GRUM SULPHIDE CELL COVER, FARO MINE

2015 REVIEW

Re: 2015 Review – Grum Sulphide Cell Cover, Faro Mine

Figure 2-1. As-Built Plan for GSC Cover (after SRK 2011).

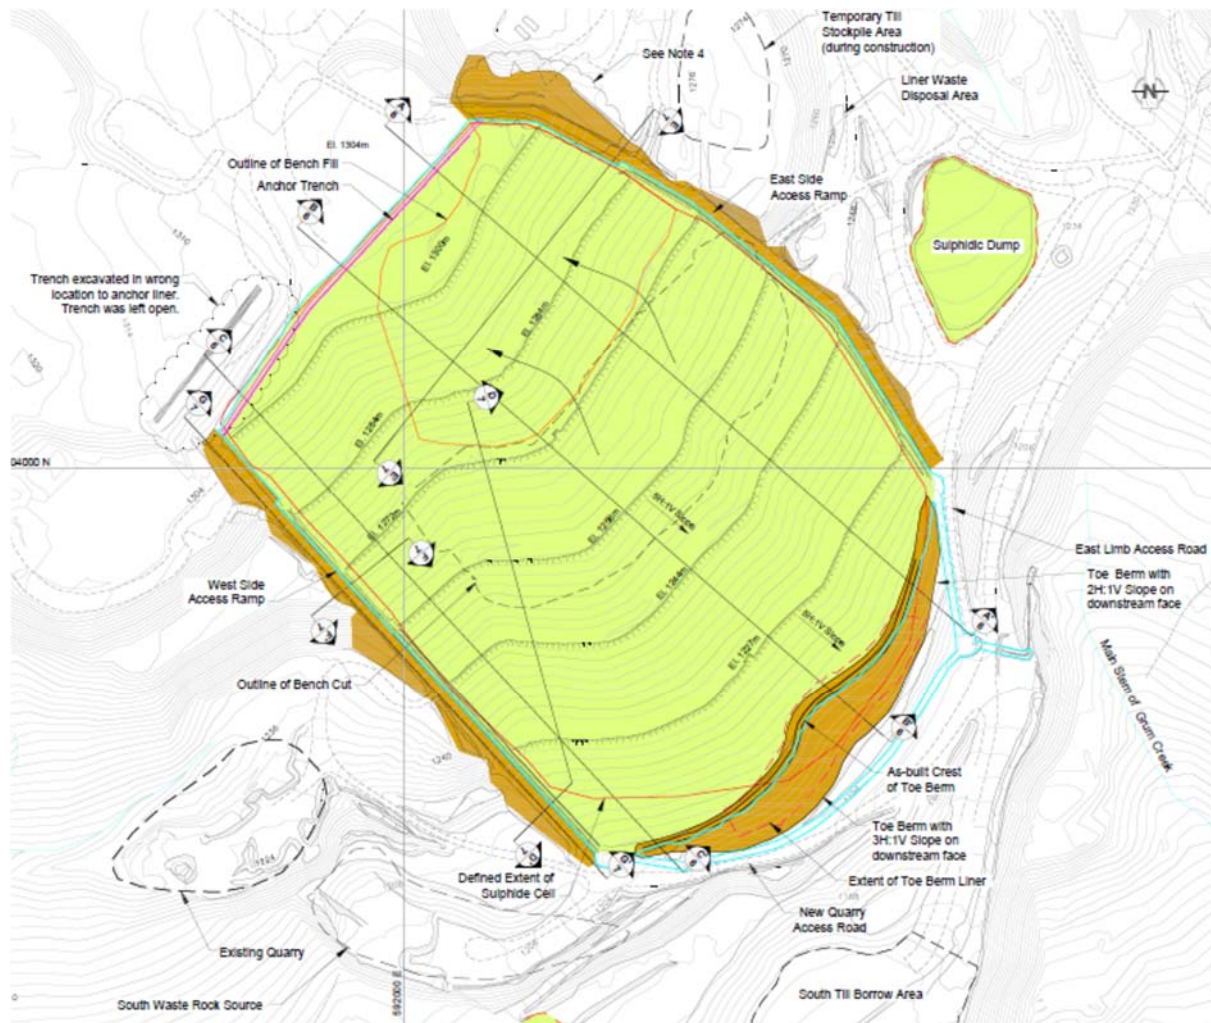
As-built information for the GSC cover is provided in SRK (2011) for the original construction in 2010, as shown in Figure 2-1. Major components of the final design are as follows:

- Resloping of GSC dump slopes to 5H:1V (or flatter) and establishment of benches at horizontal intervals of 60 to 85 m (elevations 1284, 1272, 1258, 1244 and 1227 m).

- Construction of lateral containment ramps (with ditches) on the west and east sides of the cover.
- Construction of a Toe Berm (with clean waste rock) at the base of the GSC cover including geomembrane installation.

- Installation of textured (one side) 60 mil HDPE liner over the resloped GSC surface (totaling approximately 28 ha between GSC cell and Toe Berm areas).

- Placement of 1 m of uncompacted till layer over the liner and Toe Berm. The till material was classified as a low plastic clay from Atterberg Limits test results.

- Placement of 1 m layer of sand / geotextile / waste rock along GSC benches.
- Construction of energy dissipation pools and water management structures to direct surface runoff from the cover to Grum Creek through a half-culvert.

Figure 2-3. 2013 and 2014 Total Zinc Concentrations for Both Ponds

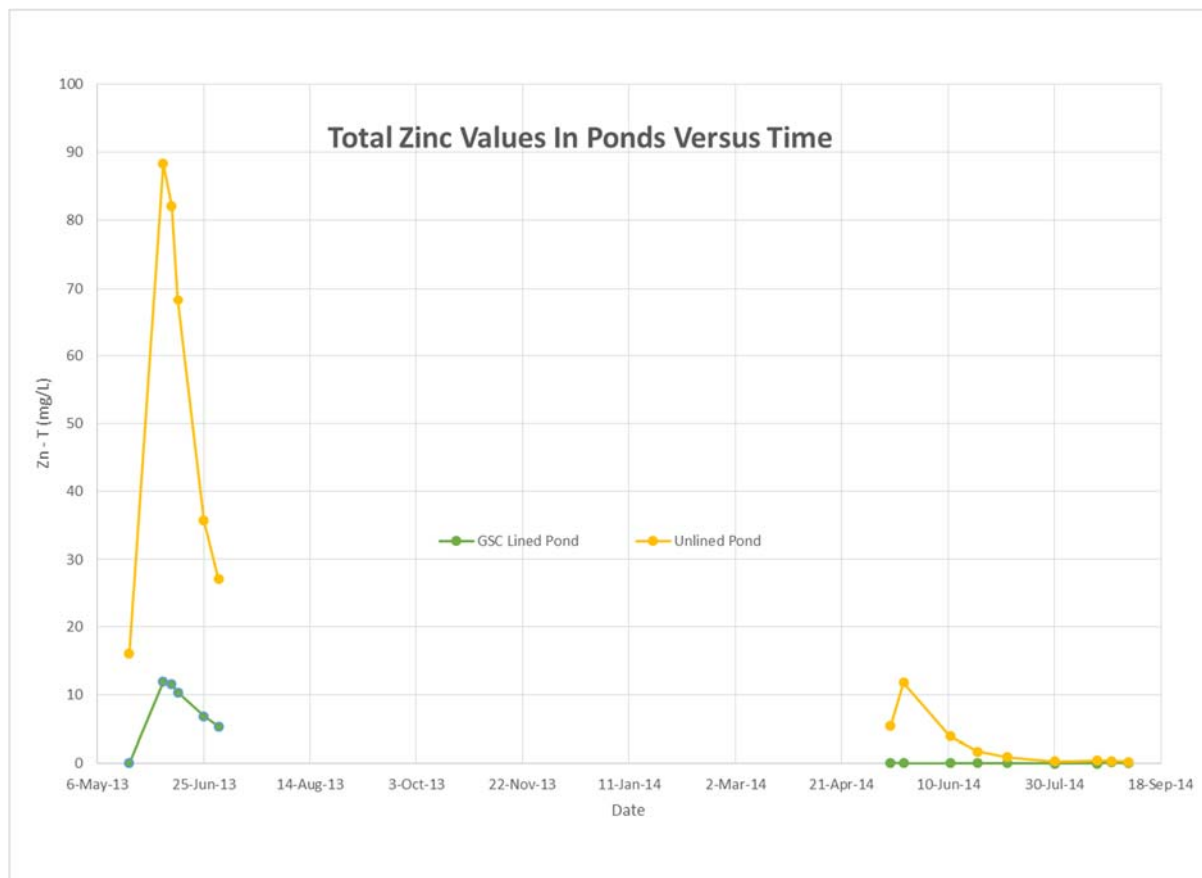
Comparing the total zinc values for the two ponds for 2014, the Lined Pond values were generally lower than 0.1 mg/L (compliant) while the Unlined Pond values ranged from greater than 5 mg/L (non-compliant) to a range of 0.23 to 0.4 mg/L (compliant). These zinc values demonstrate that the Lined Pond has lower concentrations and its run-off comes from the remediated cover surface while the Unlined Pond water comes from the unremediated waste dump surfaces. The zinc concentrations in 2014 were both lower than observed in 2013 and were considered compliant for discharge (although not for TSS on occasion), likely driven by either changes to cover water balance (current understanding is limited) and/or to a reduced amount of cover erosion and vegetative cover taking hold. If the cover contact water was compliant for discharge for all discharge parameters (total zinc and TSS), it would make sense to discharge compliant water to the toe of the dump rather than mixing with non-compliant water in the pit for treatment.

Figure 3-1. Grum Station Average Daily Temperatures since 2010.

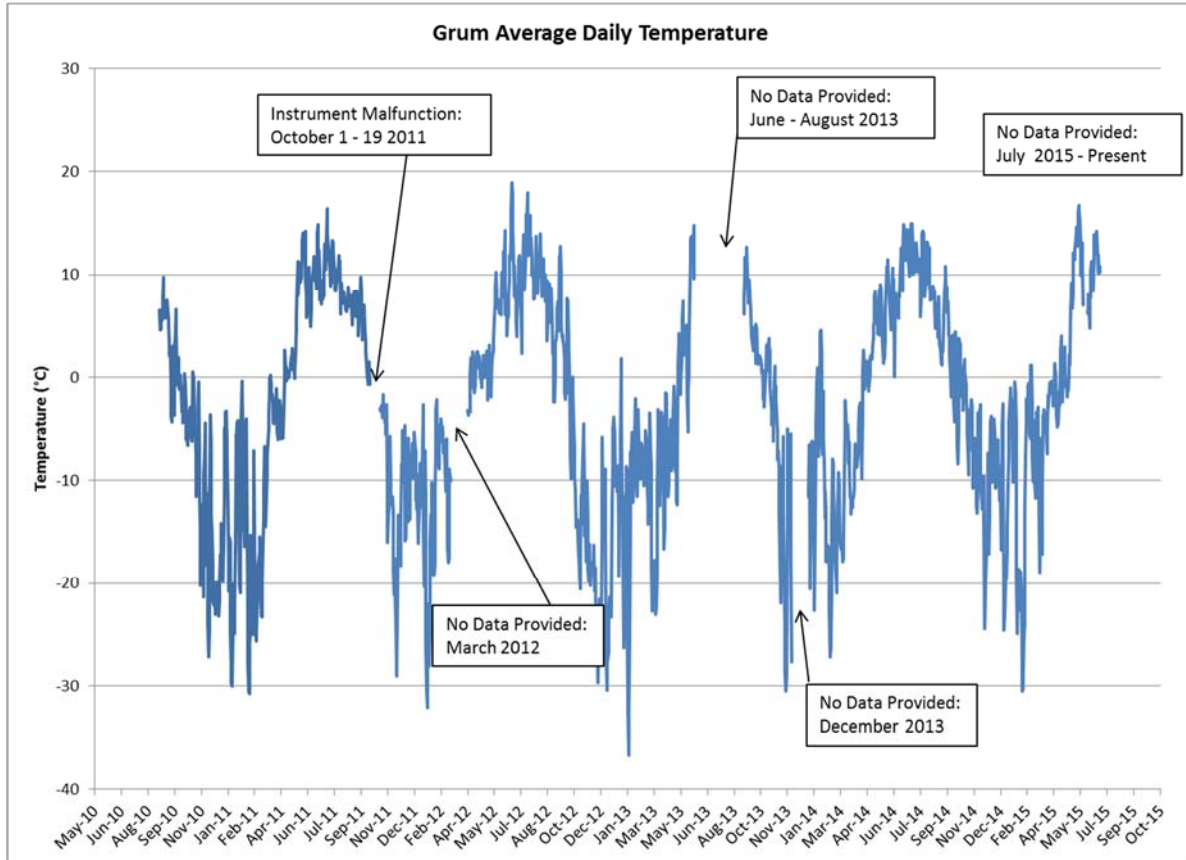
Temperature ranges recorded in 2015 were generally in agreement with previous years, although summer 2015 had higher temperatures than summer 2014 (incomplete data for summer 2013), but lower than peak values from summer 2012. Winter 2014/15 appeared warmer than previous winter values, on average. Precipitation values in 2015 were similar to ranges from previous year with two significant rainfalls events greater than 10 mm per day in summer 2015.

Figure 3-3. Faro (Aut) Monthly Precipitation Values for 2014 and 2015.

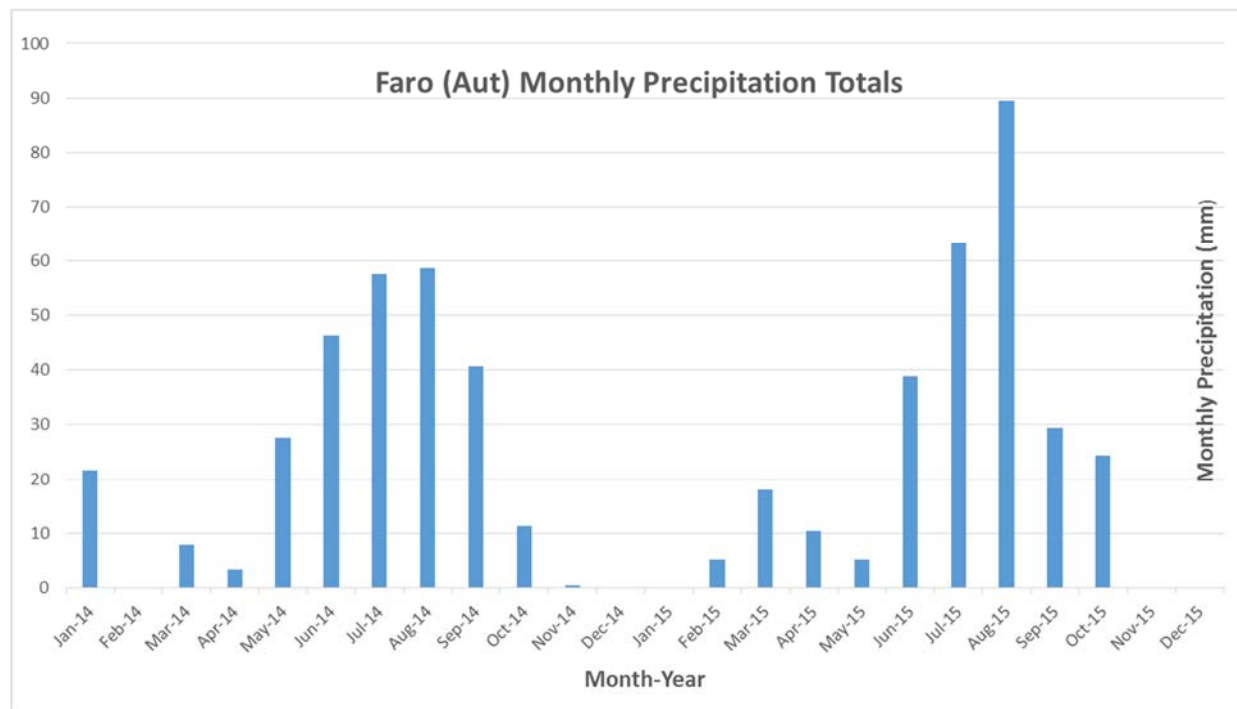
Although there is a slight difference in the distribution of the monthly precipitation between the two years, the totals are similar; 275 mm for 2014 and 284 for 2015.

Figure 3-4. Spring Temperature Daily Values for Four Years.

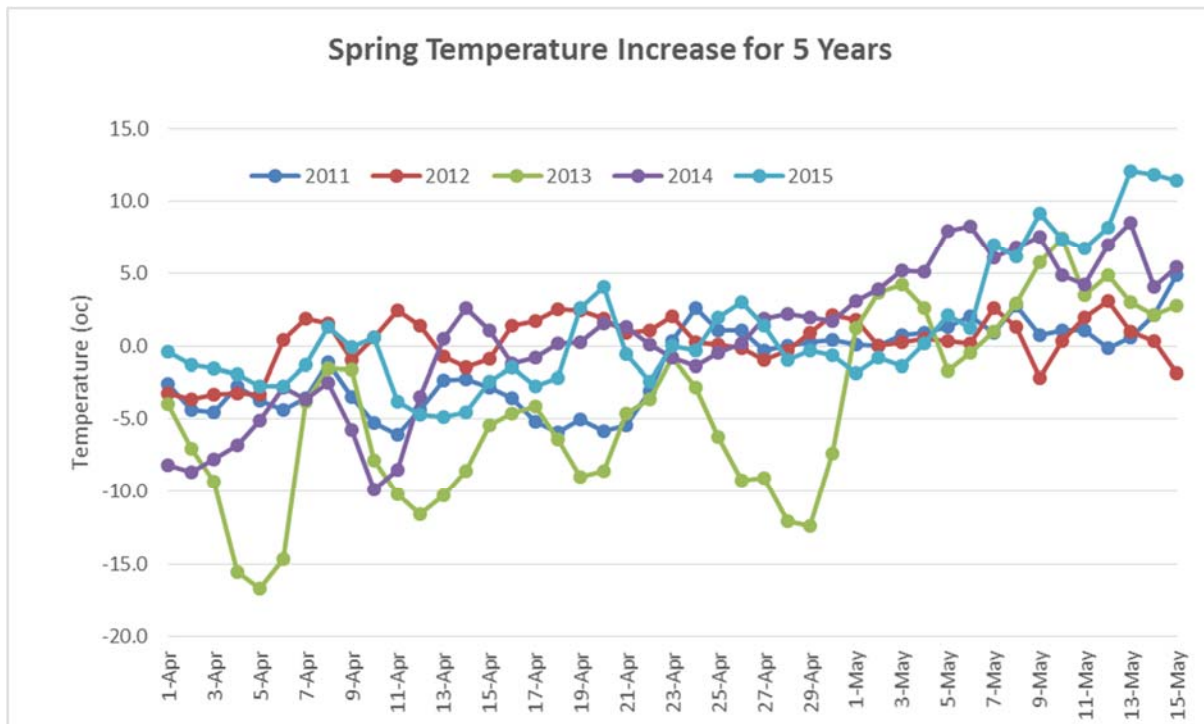
The plot shows that in the springs of both 2011 and 2013, the air temperature rise from subzero to above zero was rather rapid (on the order of four days for 2011 and 2013), resulting in a rapid melting of the snowpack. In spring 2012 though, the daily temperatures oscillate around zero for weeks (perhaps on the order of 30 days), which may have been partially responsible for a slower melt of the snowpack, releasing run-off at a slower rate. The warming trend in 2014 also showed an oscillating behavior (around 0°C) over 13 days, warming above zero consistently thereafter. In 2015, the air temperature oscillated around 0°C from April 7th until May 6th (approximately 30 days) when it consistently stayed above zero thereafter. Although different specific issues occurred in 2011 and 2013, the slower warming of the snowpack appears to result in less erosion to the cover as discharge can occur over longer time.
